PARTS & SERVICE NEWS

REF NO.	AT99038
DATE	Apr. 12, 1999

SUBJECT: REPAIR PROCEDURE OF TUBE FROM E/G TO T/C COOLER ON WA800/900, WD900

PURPOSE: To introduce modification procedures to prevent disconnection of the torque converter cooler piping (water piping) on WA800, WA900 and WD900 wheel loaders

1. Introduction

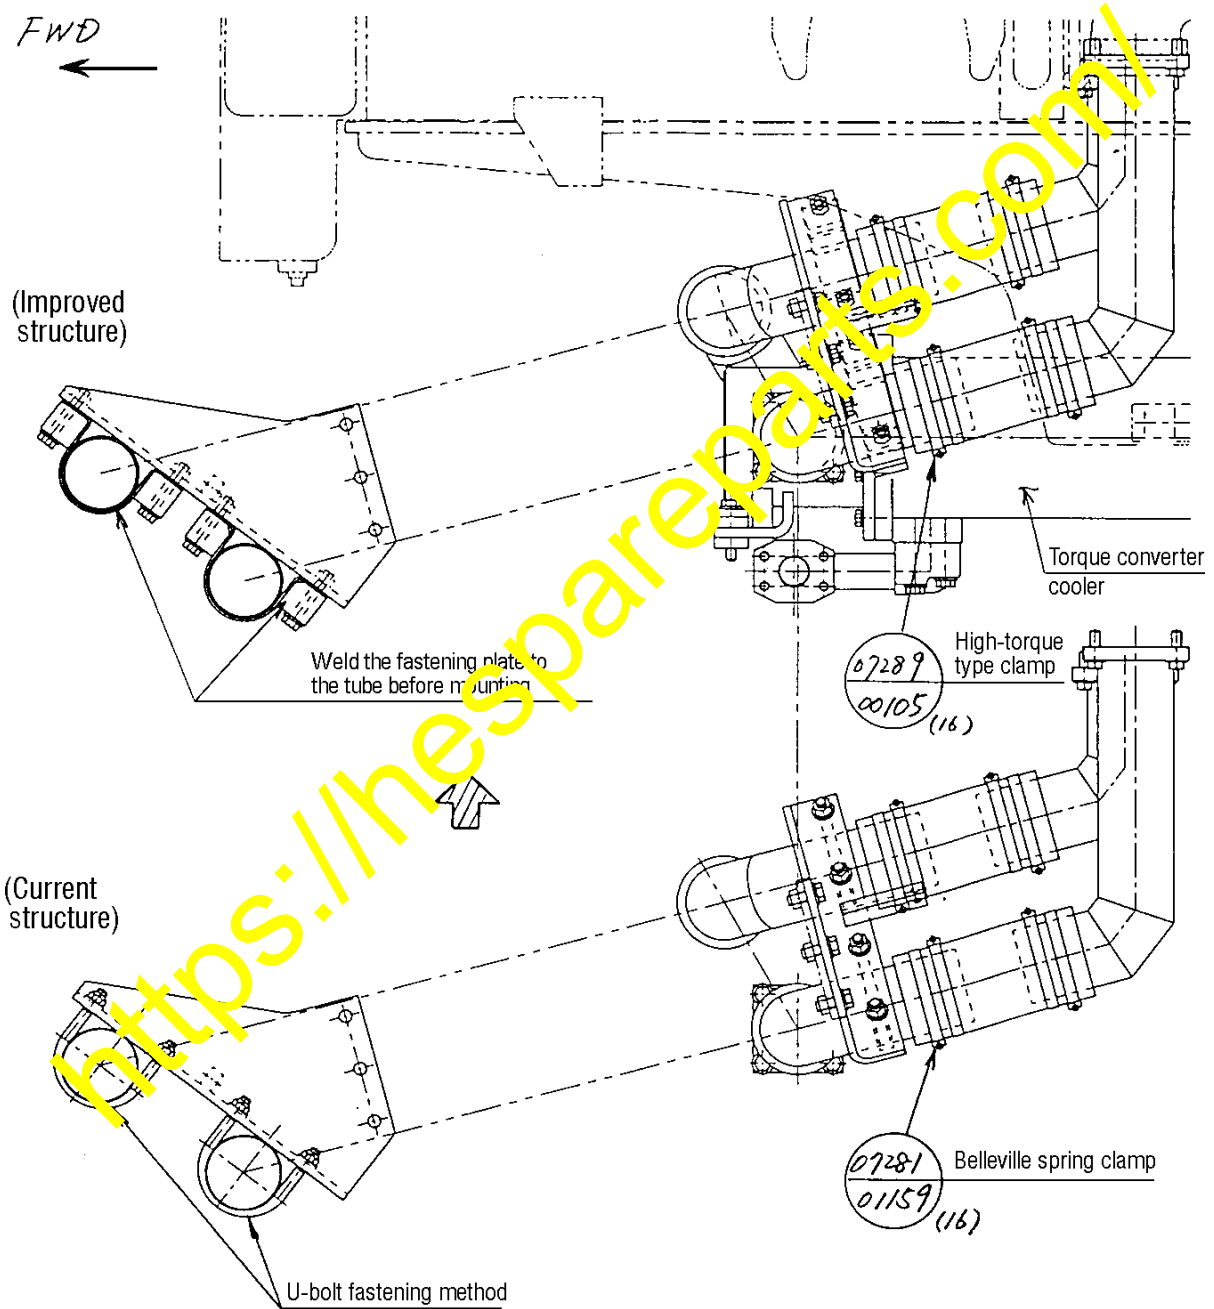
By deformation of the tubes connecting between the engine and the torque converter cooler on the WA800, WA900 and WD900 wheel loaders, the U bolts fastening these tubes may become loose to cause slipping out of the tubes from mating hoses by pressure of the water and by vibrations occurring while the machine is in operation. To prevent the above failure, make the modification introduced in this Service News by changing the designated parts to the improved versions.

- ① Modify the fastening method for the tube connecting between the engine and the torque converter cooler.
 - Change the current U-bolt fastening method to a new method where the tube fastening plate is welded to the tubes before mounting them to their positions.
- ② Modify the type of clamp for the hose connecting between the engine and the torque converter cooler.
 - Change the belleville spring clamp to the high-torque type clamp.

4. Parts to be removed

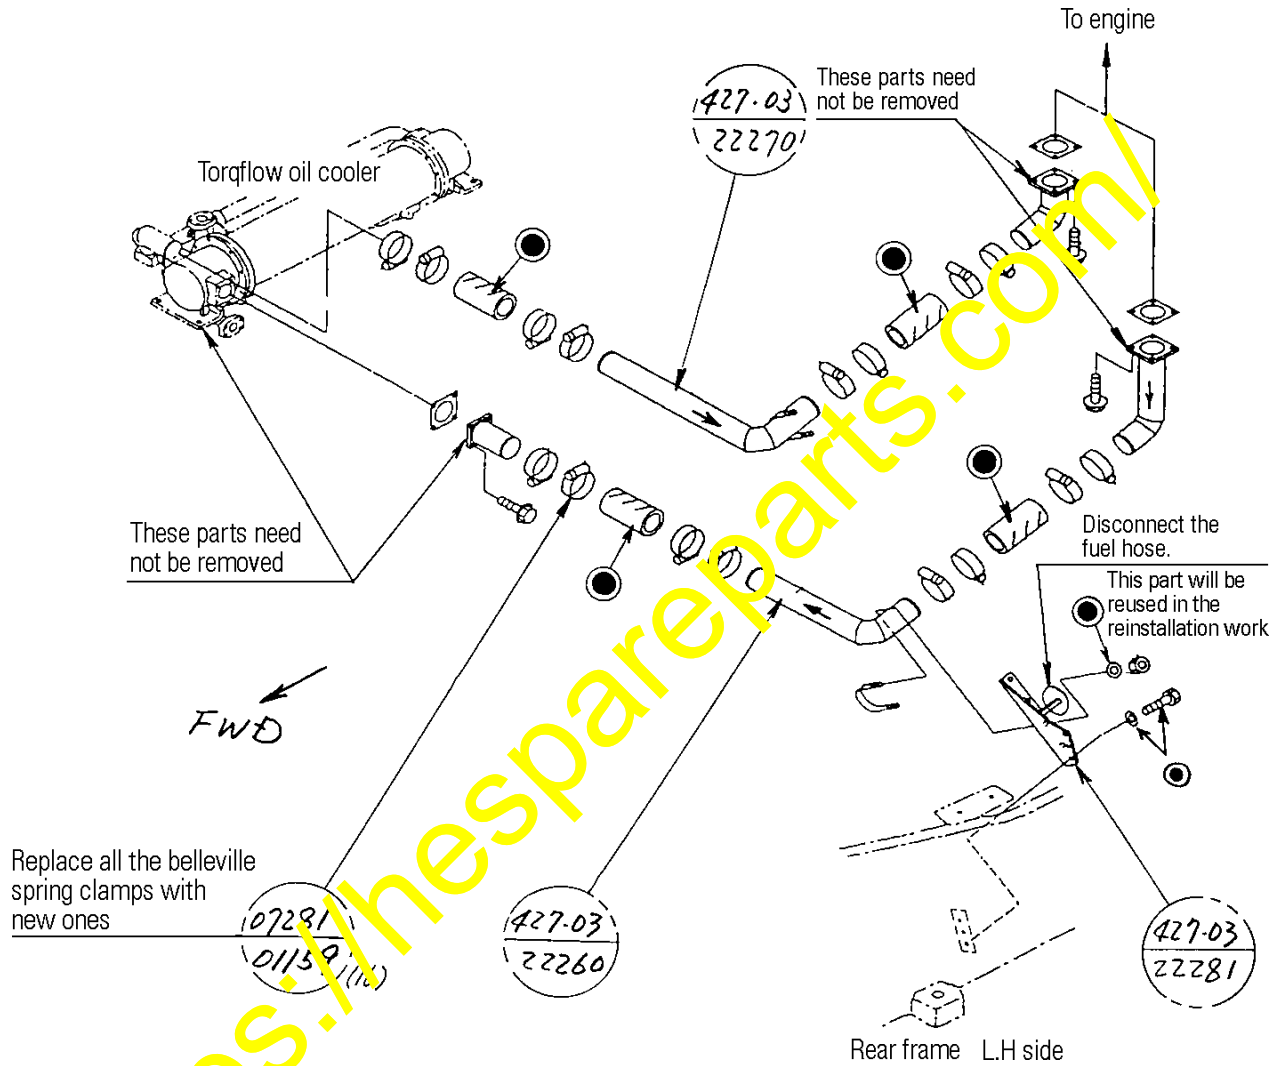
- Remove the parts with the part numbers circled in the ⊕ mark in the schematic diagram given below.

(Caution) Carefully preserve the parts marked ● since they are reused in the reinstallation work.

5. Reinstallation procedures

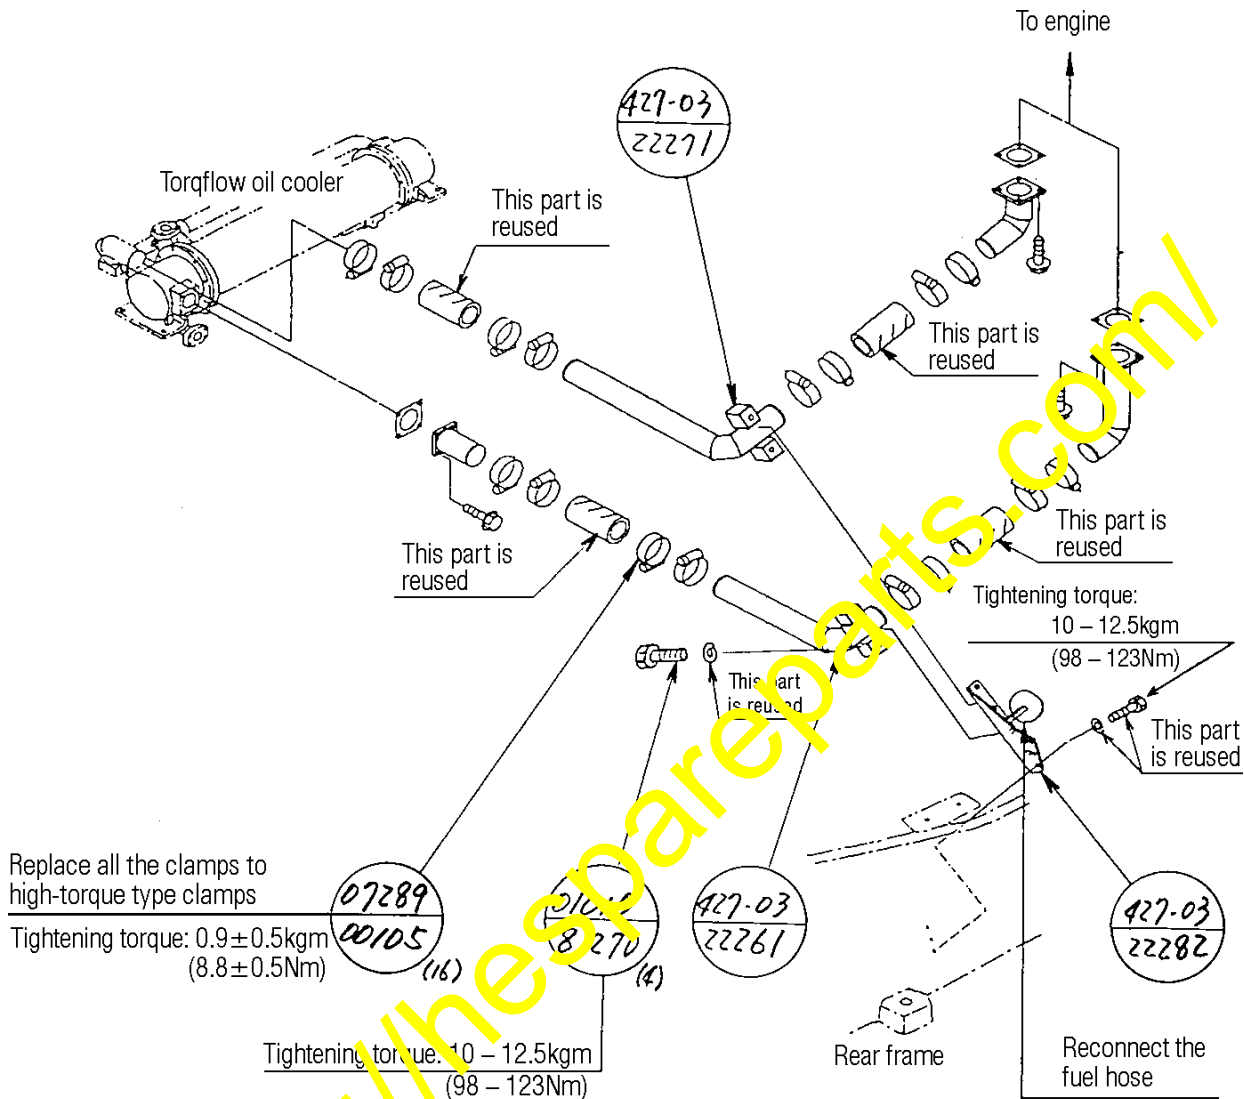
- Install the parts with the part numbers circled in the ⊖ mark designated in the schematic diagram given below.

(Caution) When inserting the tubes into the hose, insert them as far as the dimension designated in the diagram given at right.

Also, apply Three-Bond's 1208E over the periphery of the tubes where the hose is fitted (75mm).
